Addendum No. 1

Project: The Brando for Bluestone Development

Date: 15 April 2013
From: Studio 951, Ltd.
To: All plan holders.

X 9 NORTH ELEVATION - PARTIAL
1/8" = 1'-0"

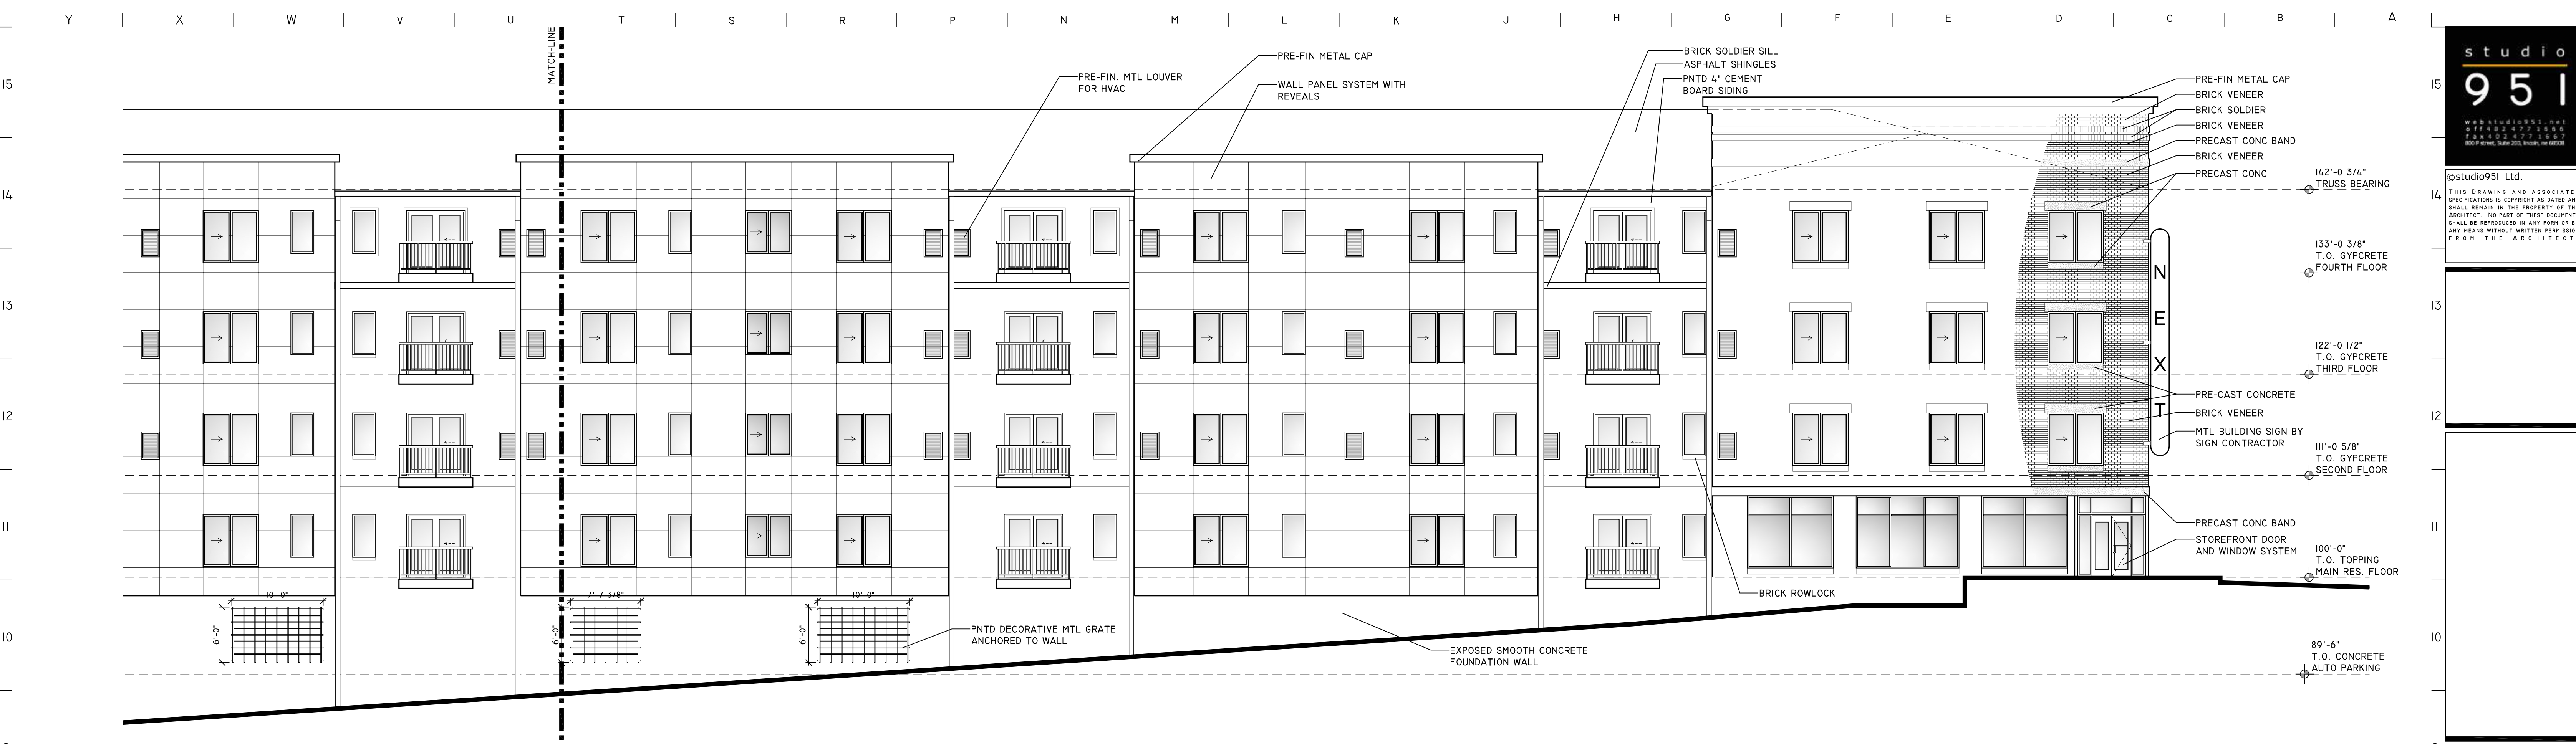
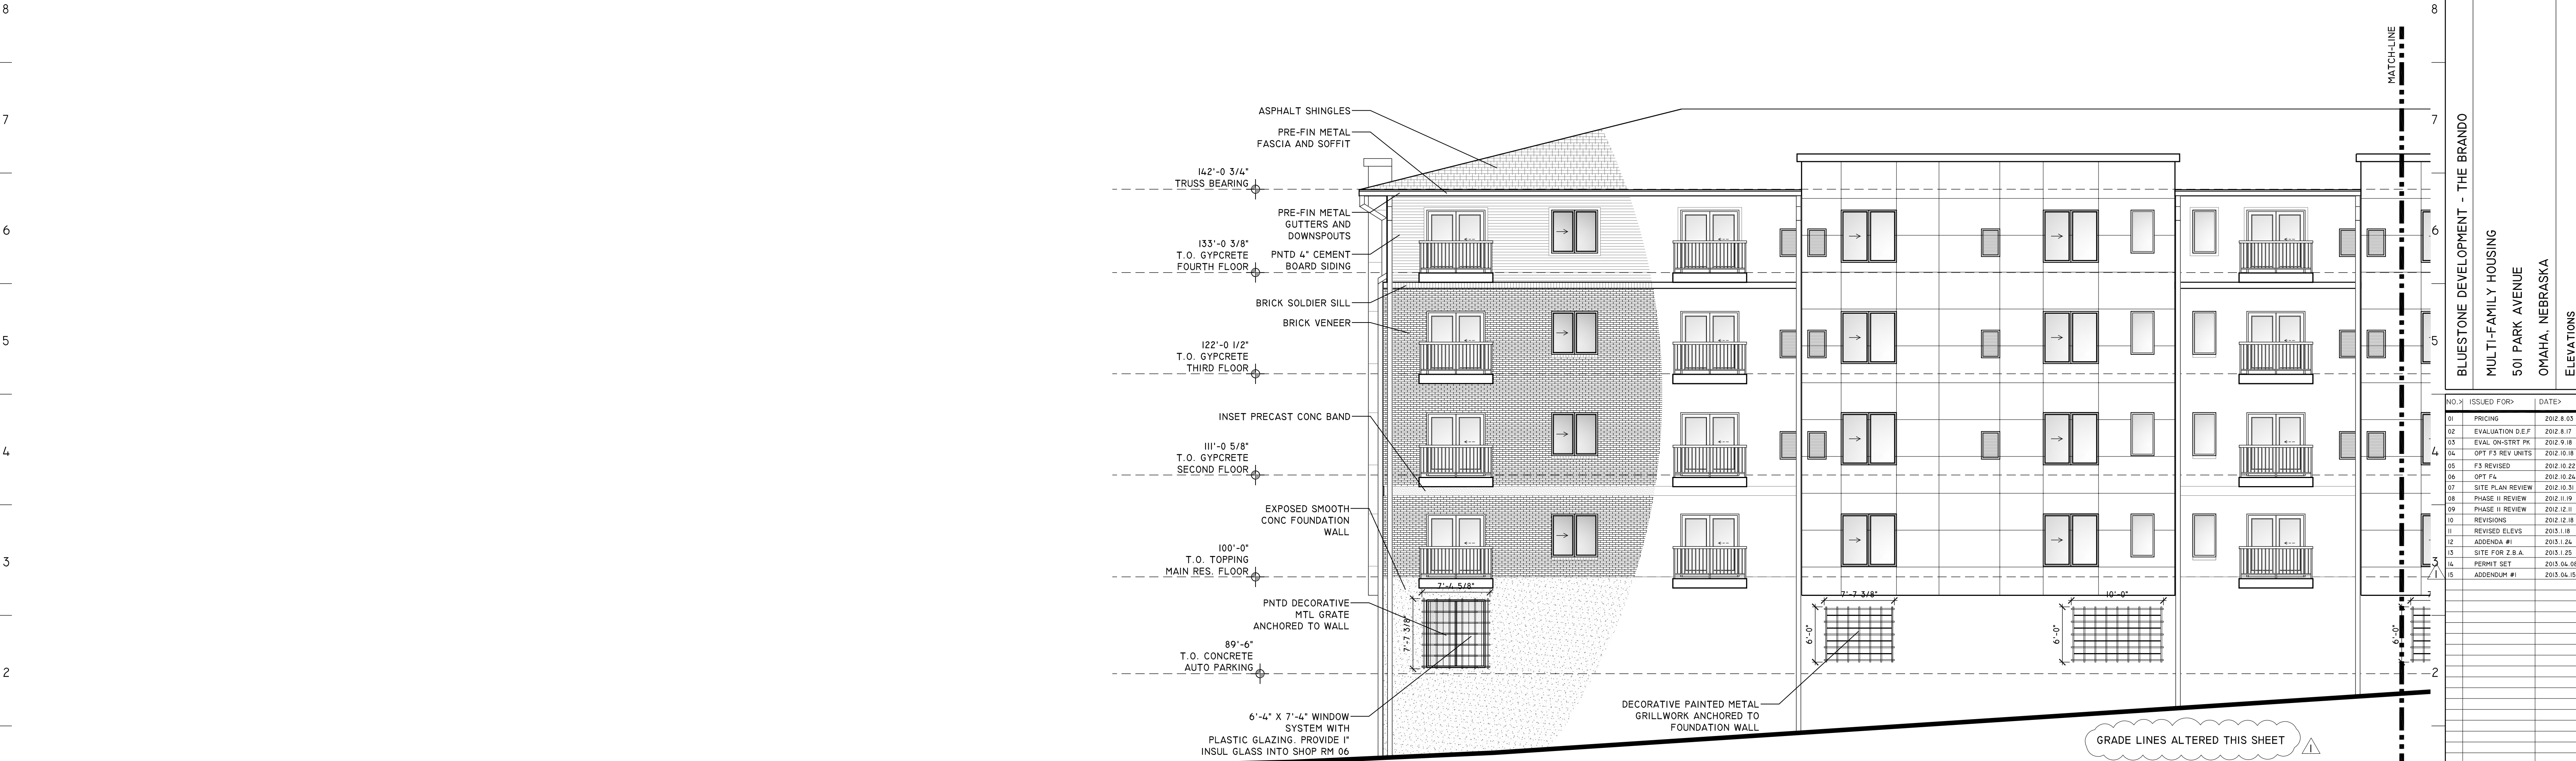
Note that window G at the end of the corridors on the south elevation, has been changed to window type D. This applies to all residential floors.
